# GUAM POWER AUTHORITY

**AMENDMENT NO.: VII**

**INVITATION FOR MULTI-STEP BID NO.: GPA-034-18**

**BUILD, OPERATE & TRANSFER CONTRACT FOR 180MW OF NEW GENERATION CAPACITY  
STEP 2 – TECHNICAL SPECIFICATIONS**

SUBSTATION BREAKER TO BREAKER  
REFERENCE DRAWING  
HARMON SUBSTATION

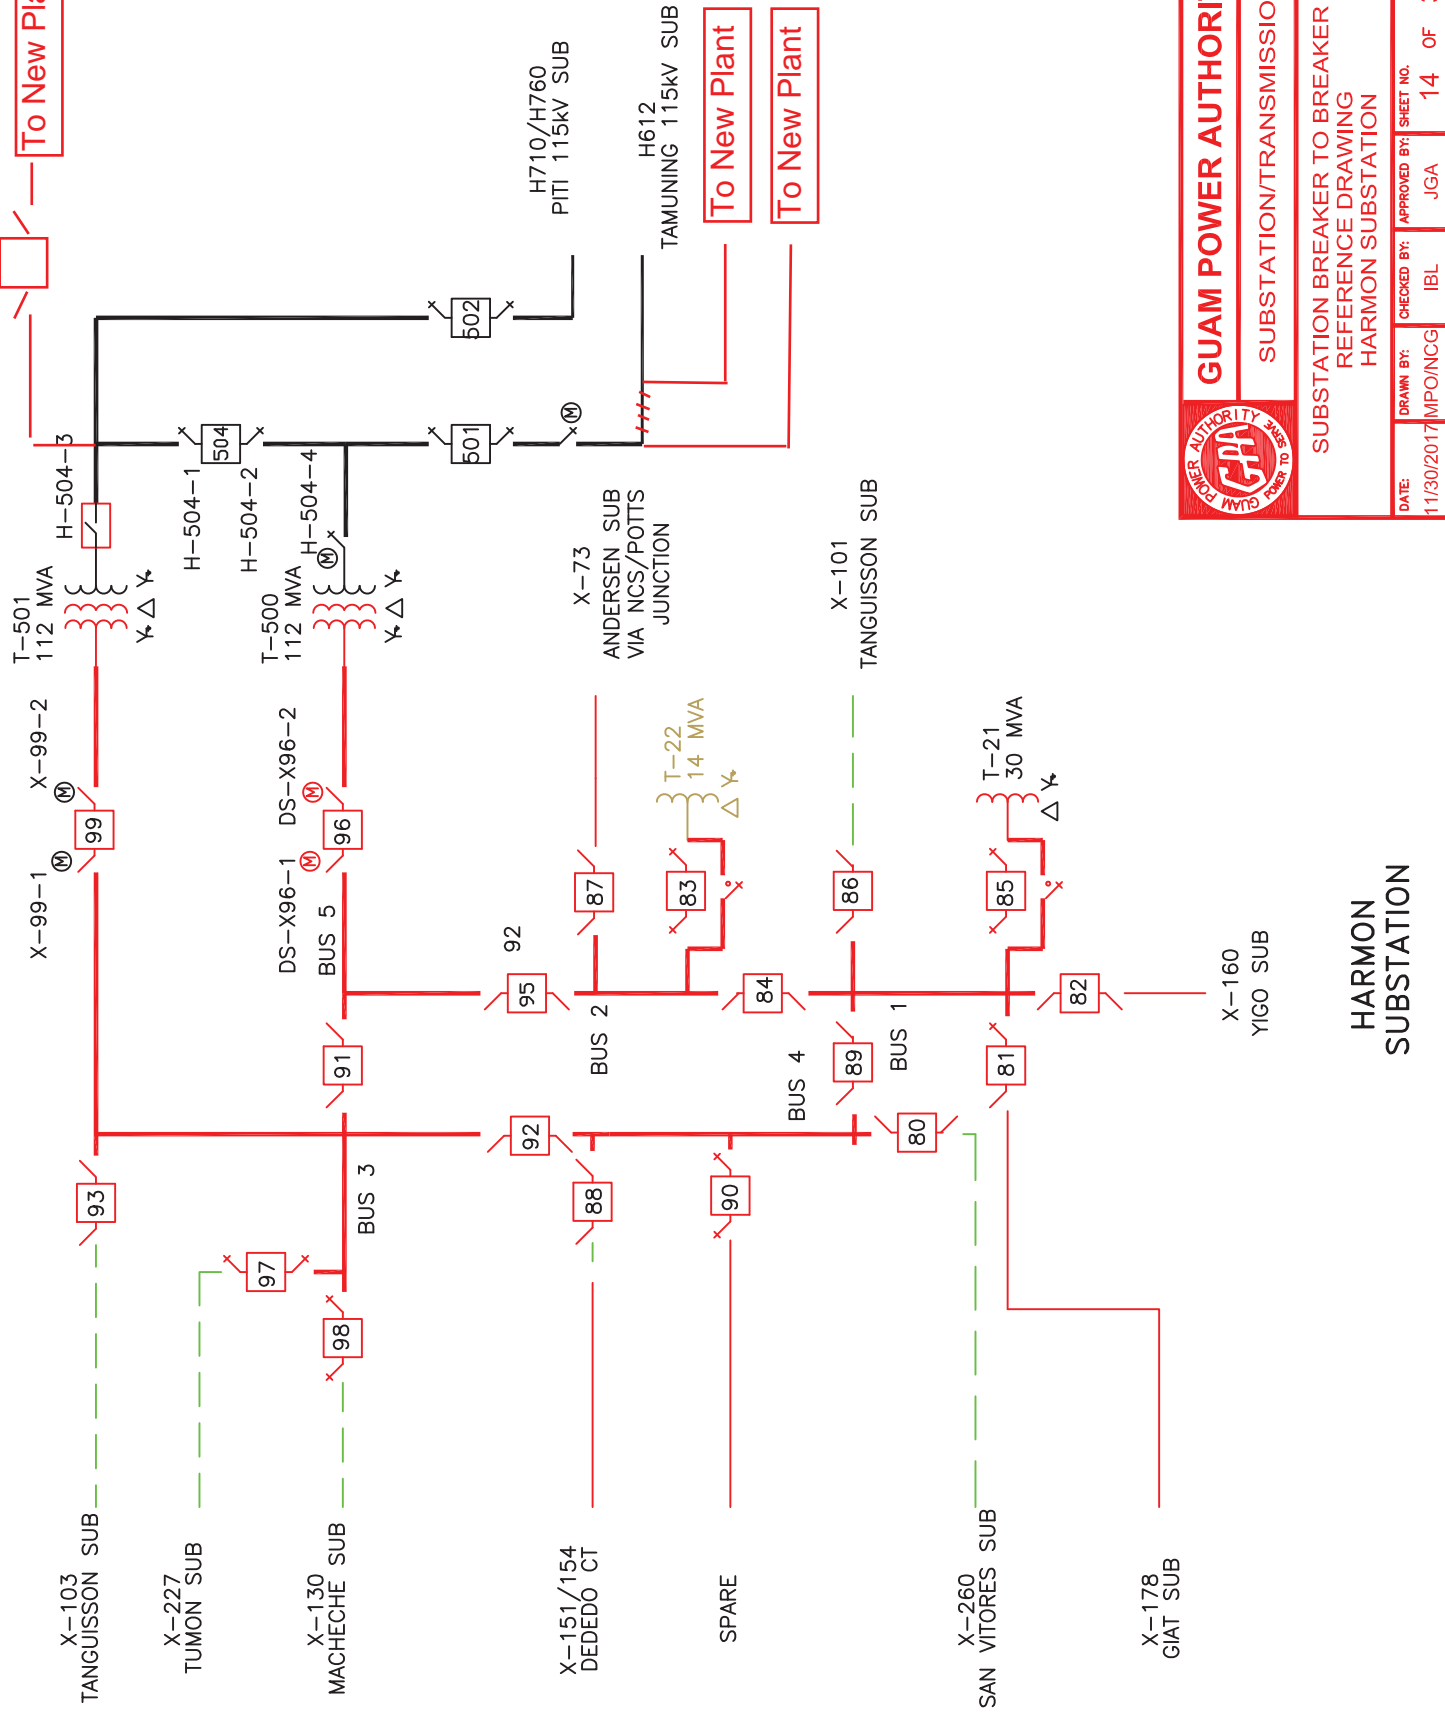
We assume that the scope of expansion/modification is limited only to works necessary for tying-in the new 115 KV transmission interconnection lines (under the Project Company Scope) to the existing Harmon substation. Please confirm.

GPA shall provide details on the existing Harmon substation which need to be reviewed by the Bidder to understand the technical details of the equipment available to be modified/expanded if any. Please provide layout, diagrams and relevant data of substation.

In Amendment 1 it was clarified that three transmission connections are required. One to H501 (existing), a second to H503 (new), and a third for intercept of the existing Harmon-Tamuning 115 kV line. Regarding the new breaker and bus extension for H503, please provide further clarification of the requirements including any known requirement for additional transformer capacity.

- a. See Amendment No I response to bidder #3 question 6 for details on interconnection at Harmon substation.
- b. The new power plant will have 3-115 kV transmission lines. Two of the 115 kV lines will connect to existing H501 and new H503 breakers at Harmon Sub. The third 115 kV line will intercept the existing Tamuning-Harmon 115 kV line and be rerouted to the new Power Plant. Therefore, in the event that Harmon 115 kV bus is offline, the New Power Plant still has a line going to Tamuning Sub. Please see attached maps and layouts (Harmon Substation Layout.pdf., Pages from Substation Oneline Reference 11-30-2017.pdf, Transmission One Line 11-30-2017.pdf).
